PROJECT: City of Ferndale – Well Water Supply Project
Schedule B (Water Main)

ADDENDUM 1

**WELL WATER SUPPLY PROJECT,
SCHEDULE B (WATER MAIN)**

ADDENDUM NO. 1
To the Contract Provisions for
City of Ferndale, Washington

JOB# / DWG 10020 SP1.1ADD	DATE 5/5/11
SCALE H: 1"=20' v: N/A	SHEET 4 of 33

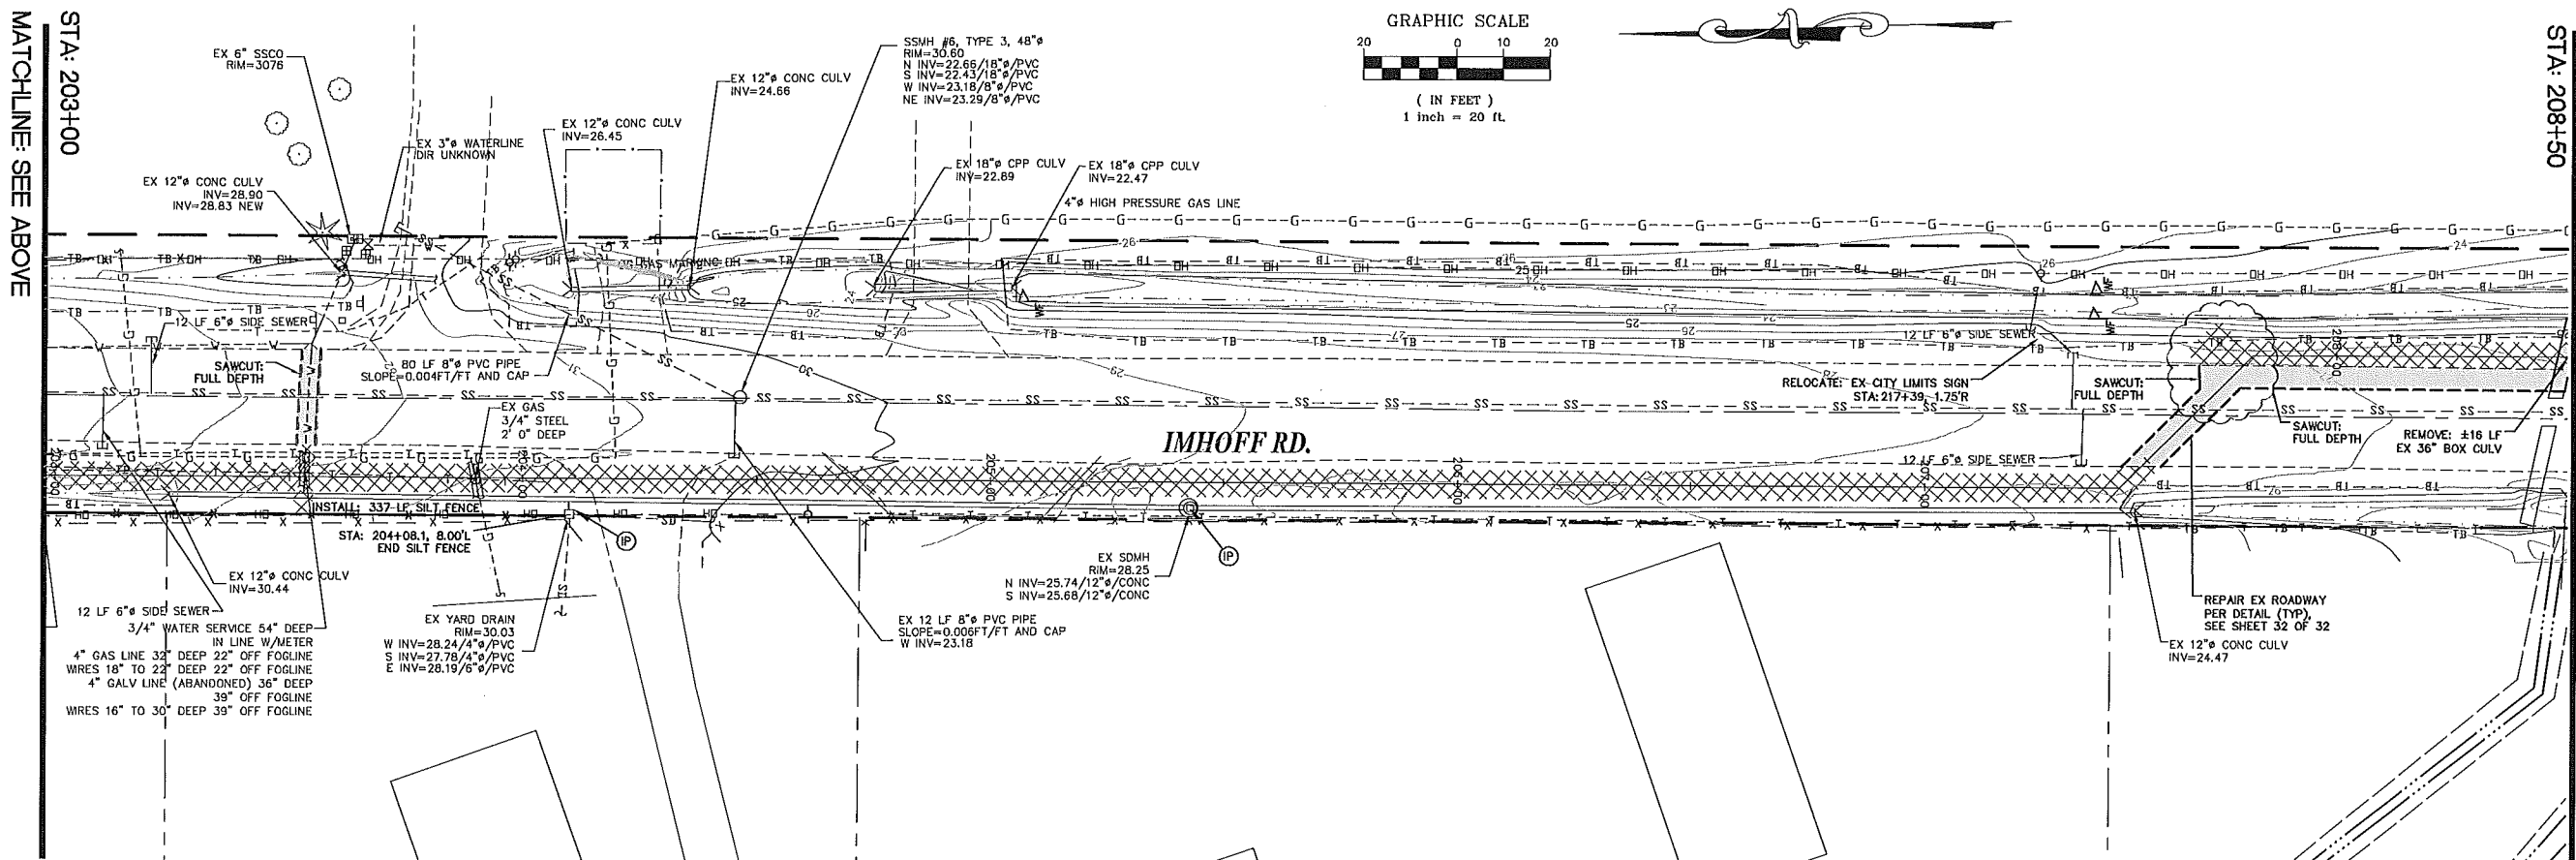
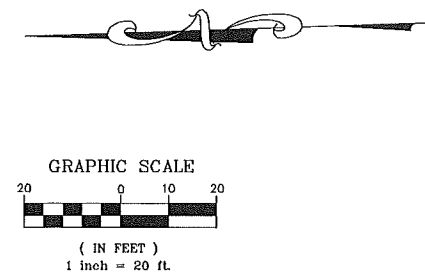
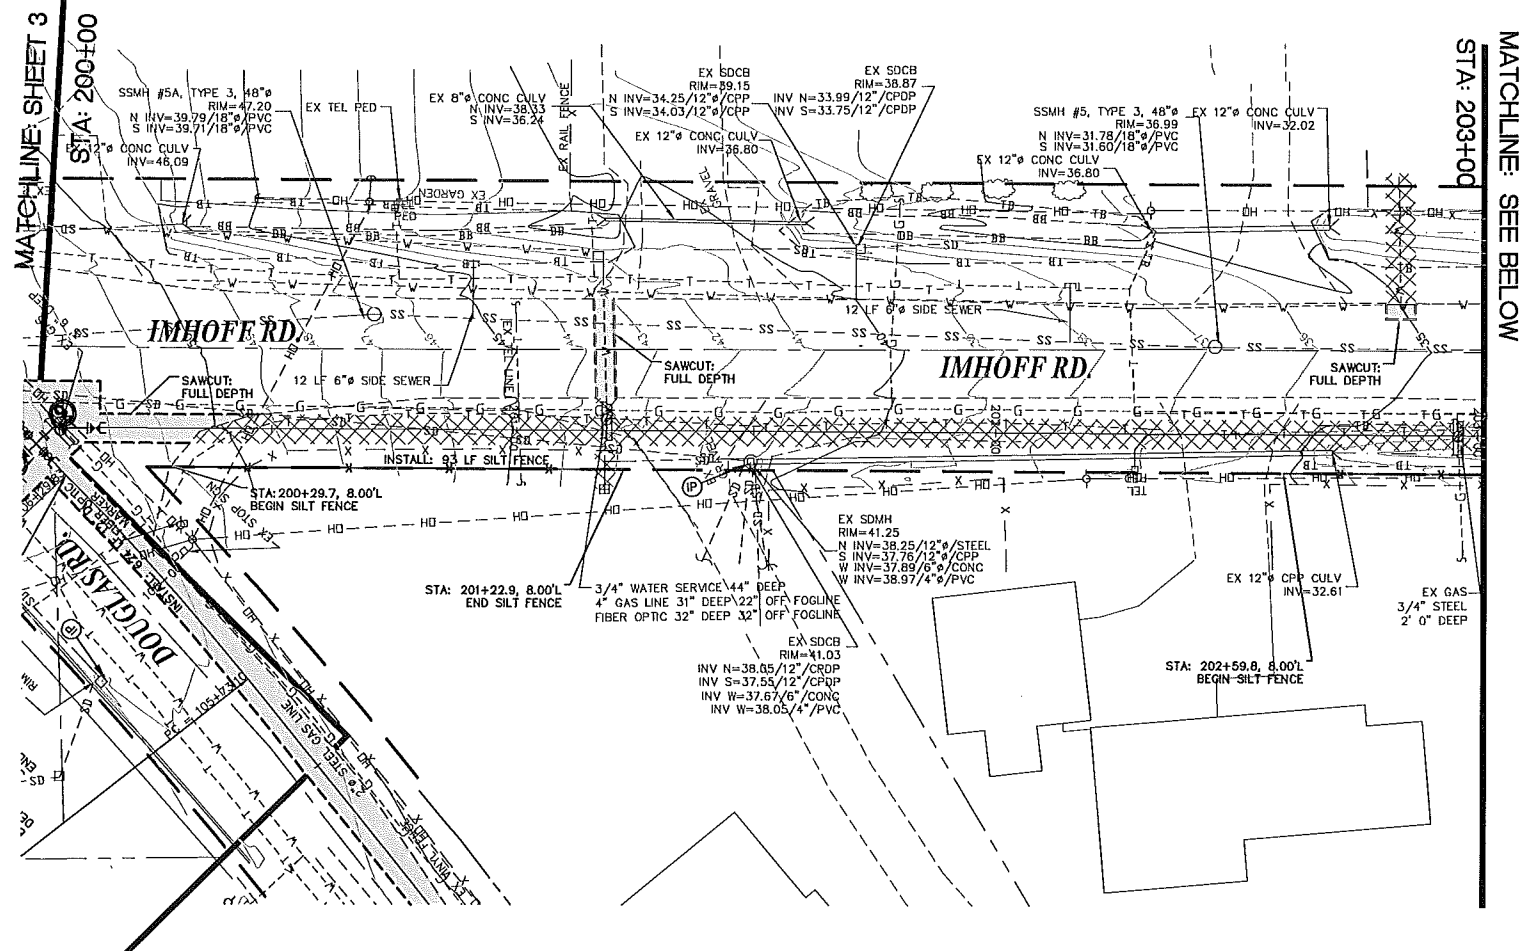
The attached Plan Sheet 4 shall replace the Plan Sheet 4 dated 4-20-10. The extents of removal along Poplar are extended; mailbox and CDF information is added.

DATE
5/5/11
SHEET
8 of 33

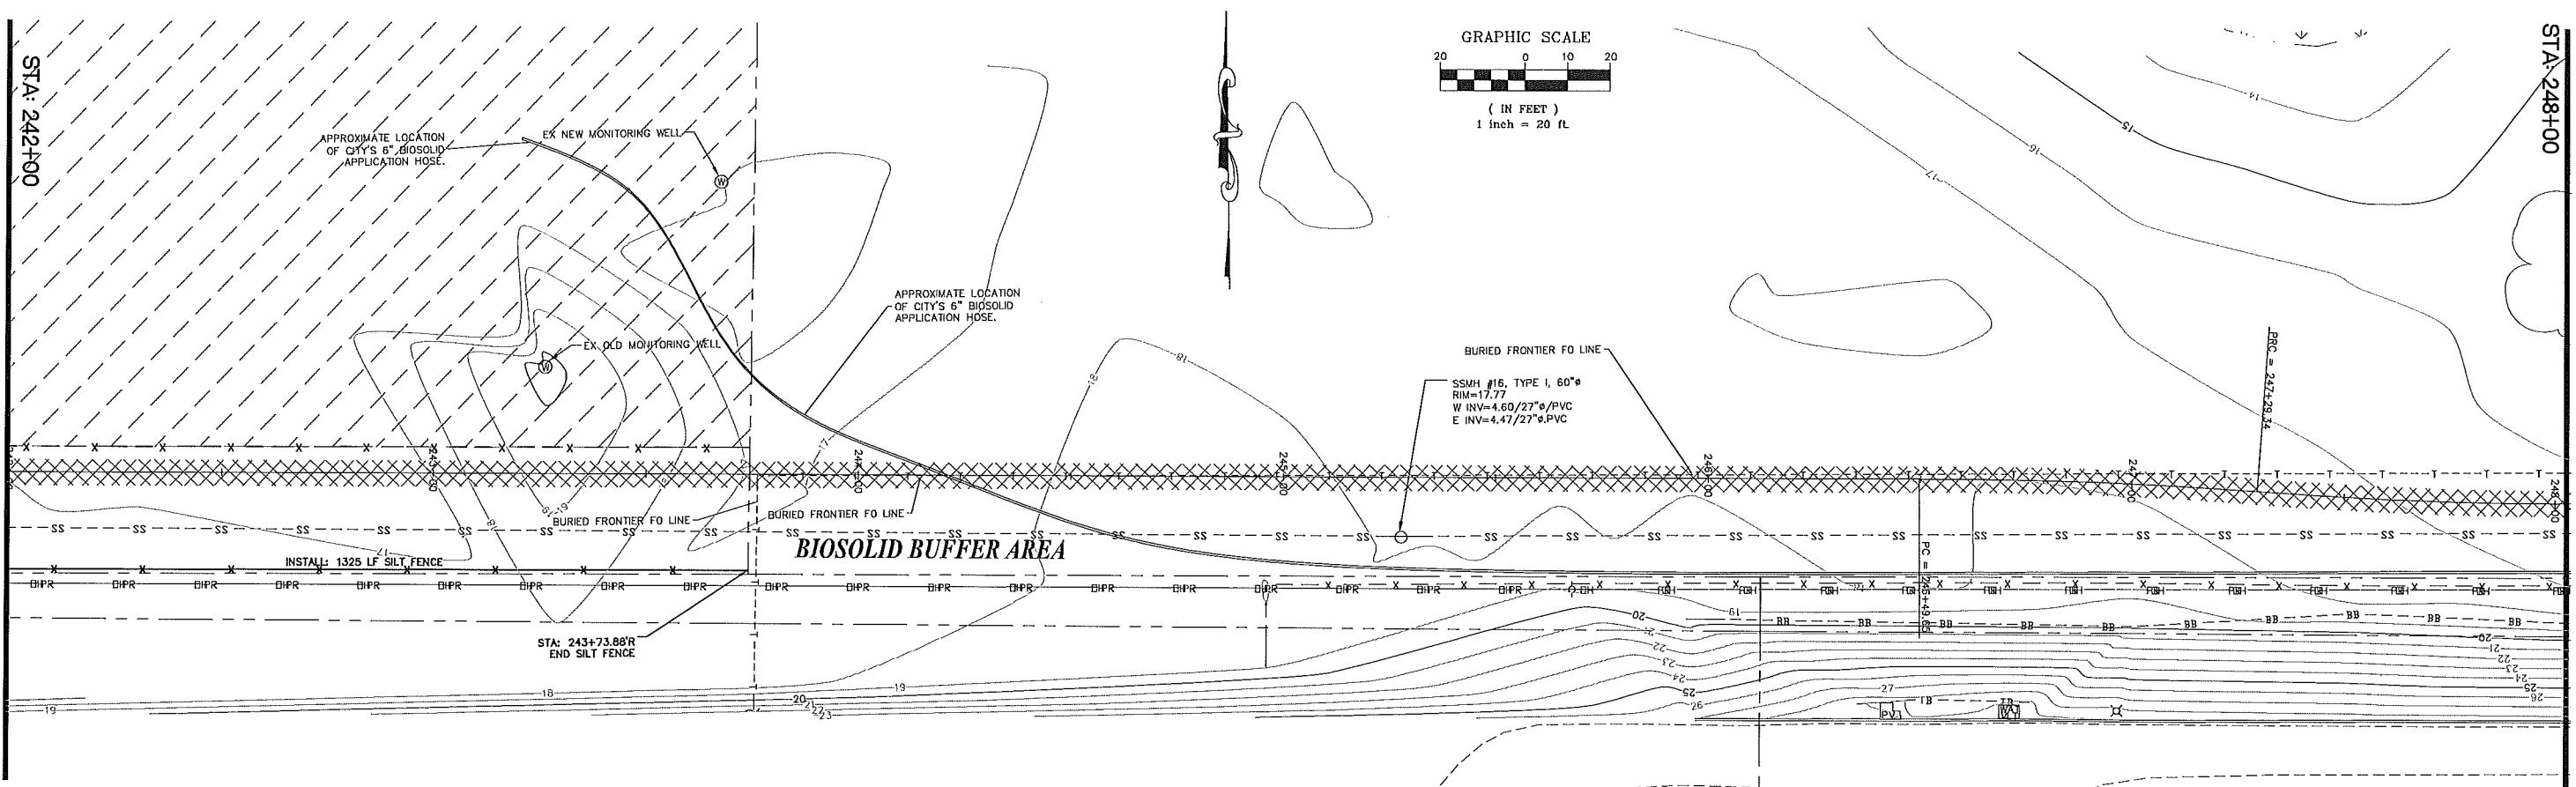
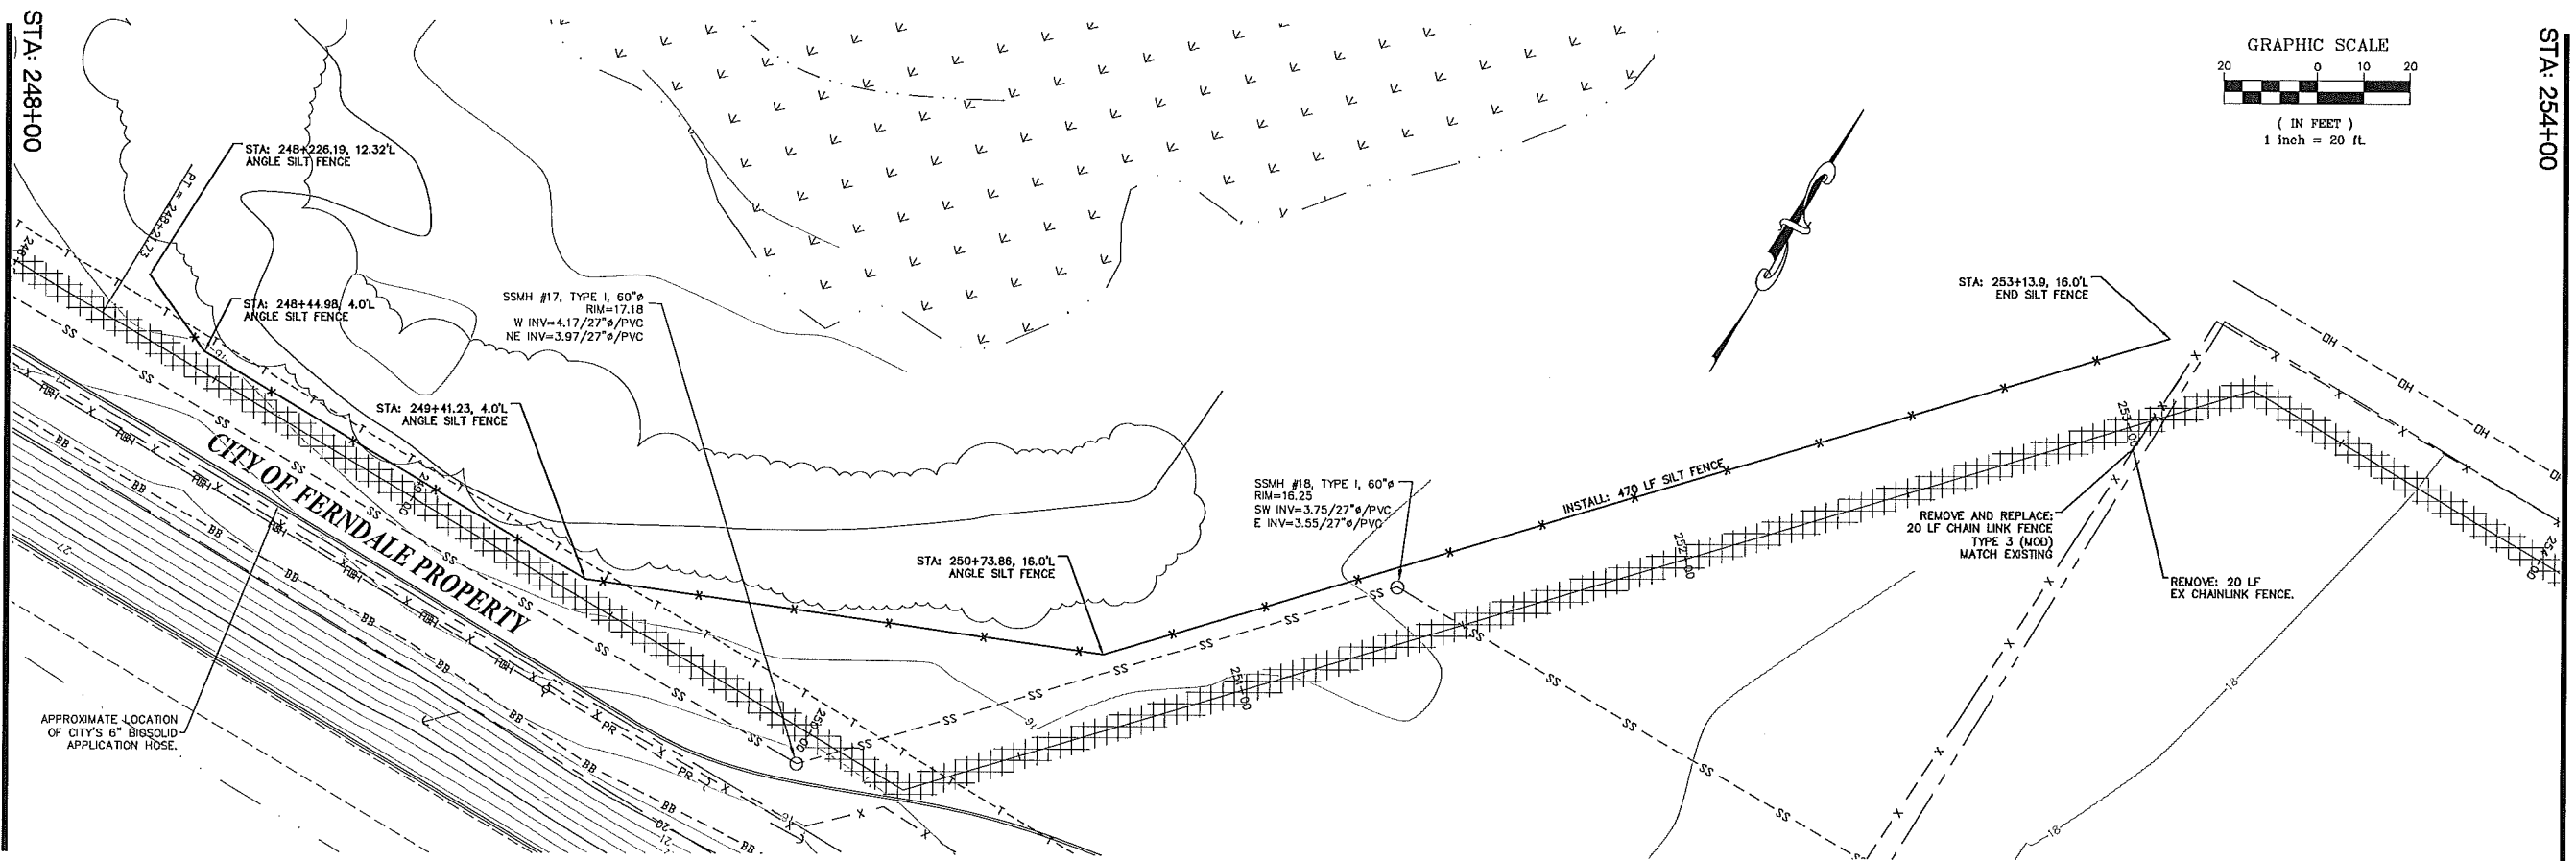
The attached Plan Sheets 8 and 9 shall replace the Plan Sheets 8 and 9 dated 4-20-10. The area of grub and remove rocks and asphalt is deleted as this work is deleted from the contract.
